# UNITED STATES PATENT AND TRADEMARK OFFICE

APPLICATION NO.	FILING DATE	FIRST NAMED INVENTOR	ATTORNEY DOCKET NO.	CONFIRMATION NO.
10/759,877	01/16/2004	John Boyland	0403-4107	8433

<b>Office Action Summary</b>	Application No. 10/759,877	Applicant(s) BOYLAND ET AL.	
	Examiner Jeffrey Sharp	Art Unit 3677

### **DETAILED ACTION**

Grieser et al. US-5,641,240

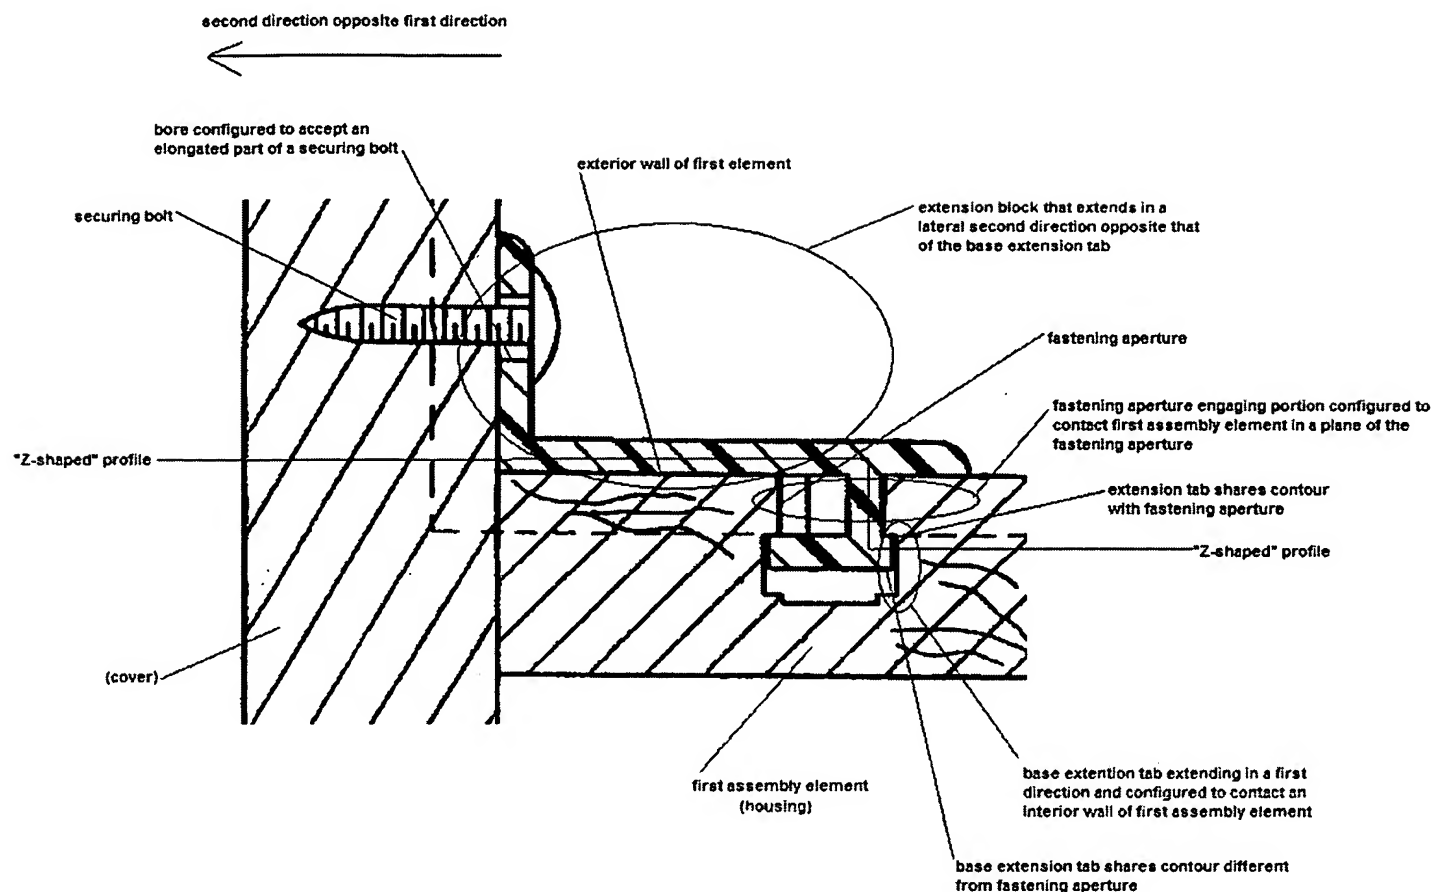
[5] Claims 1-4, 7, 9, 12, 20, and 21 (as they are understood) are rejected under 35 U.S.C. 102(b) as being anticipated by Grieser et al. US-5,641,240.

In short, Grieser et al. teach a Z-type fastener with a Z-shaped profile, used in a housing (94)/cover (92) assembly, said Z-type fastener having:

a base extension tab (76) being provided with a surface (72) configured to contact an interior wall of a fastening aperture (98) within said housing,

a fastening aperture engaging portion (64,80) (e.g., pressure application edge),

an extension block/body (12,18,20,30) being provided with a surface (30) configured to contact an exterior wall of said housing;

wherein the extension block of the Z-type fastener has a bore (14) configured to accept an elongated part of a securing bolt/body (100), and

wherein the extension block extends in a lateral direction opposite that of the base extension tab.

Palumbo US-3,970,399

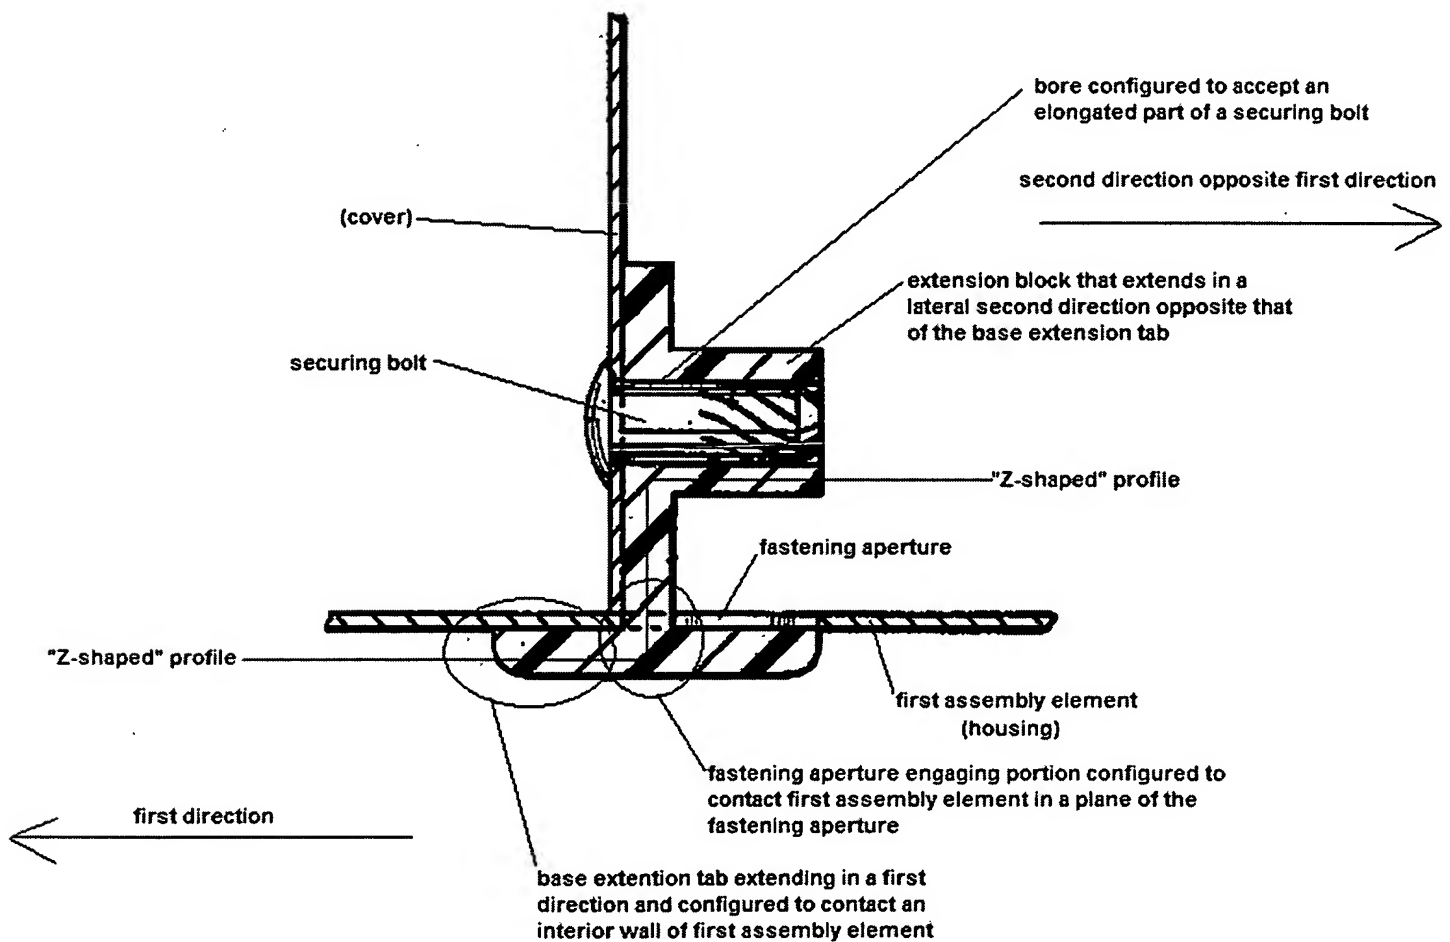
[6] Claims 1-4, 12, 14, 15, 20, and 21 (as they are understood) are rejected under 35 U.S.C. 102(b) as being anticipated by Palumbo US-3,970,399.

In short, Palumbo teaches a Z-type fastener (10) with a Z-shaped profile, used in a housing (13)/cover (12) assembly (11), said Z-type fastener having:

a base extension tab (20') being provided with a surface (15) configured to contact an interior wall of a fastening aperture (27) within said housing,

a fastening aperture engaging portion (18) (e.g., pressure application edge),

an extension block/body (17,23);

wherein the extension block of the Z-type fastener has a bore (24) configured to accept an elongated part of a securing bolt/body (32,33,34,35), and

wherein the extension block extends in a lateral direction opposite that of the base extension tab.

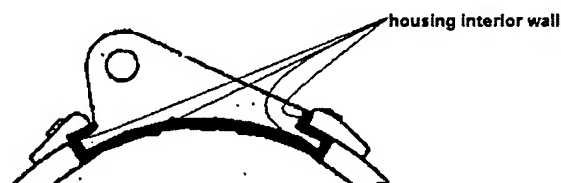
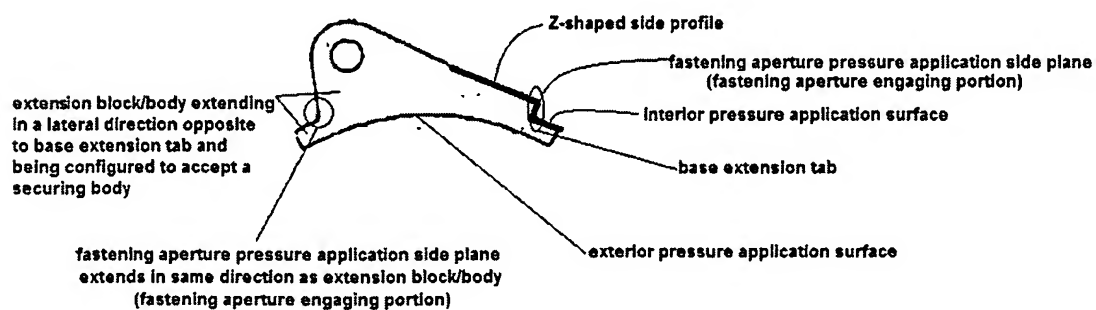
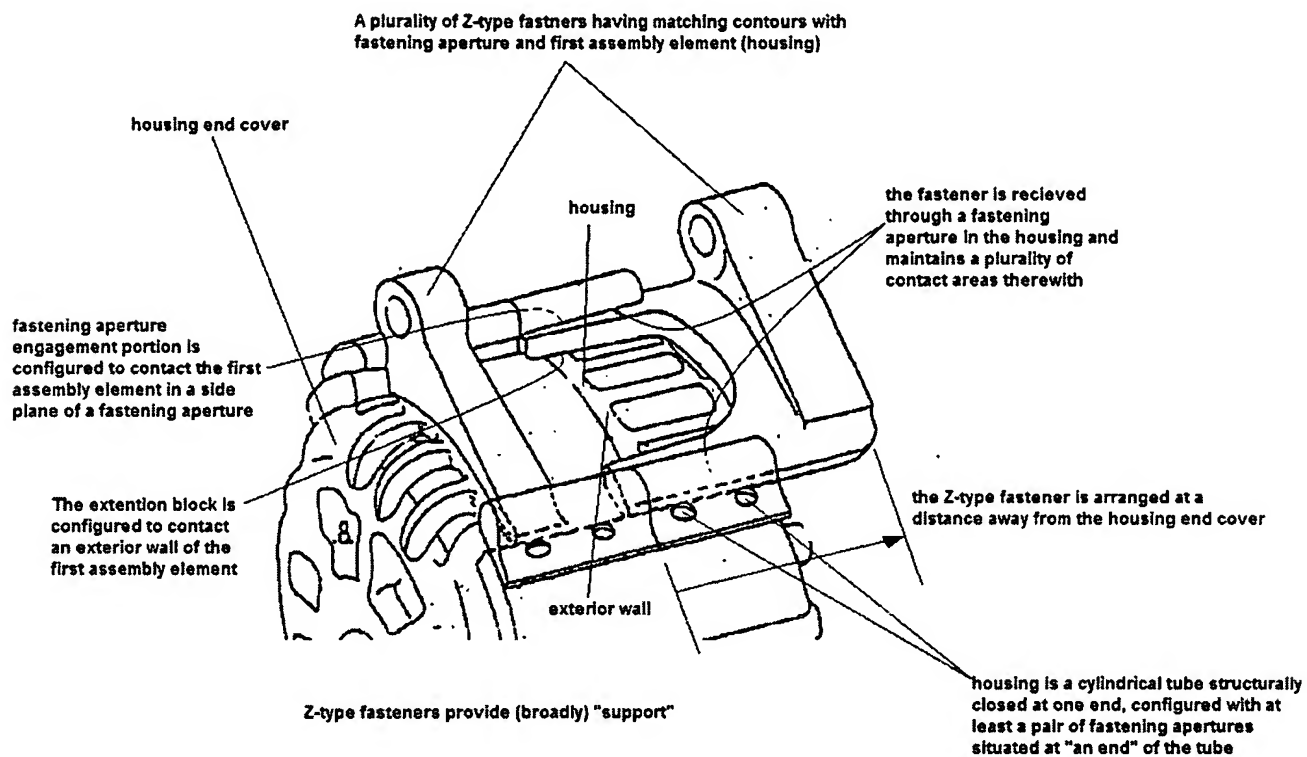
[13] Claims 1-4, 7, 9, 12, 14, 21, 22, and 25 (as they are understood) are rejected under 35 U.S.C. 102(b) as being anticipated by Wilkerson et al. US-3,378,806.

In short, and in its broadest reasonable interpretation, the Wilkerson et al. reference teaches a single element Z-shaped fastener (Figures 1-3), configured to attach a housing end cover (56) to a housing (15) via a securing body (38). The fastener has a contoured base extension tab (10), a fastening aperture engaging portion (16), and an extension block (24) that extends in a lateral direction opposite that of the base extension tab (10). The base extension tab and extension block are "configured" to apply structural support. The Z-shaped fastener is arranged at a distance away from the housing end cover (56) when the housing end cover (56) is secured to the housing (15) through the securing body (38).
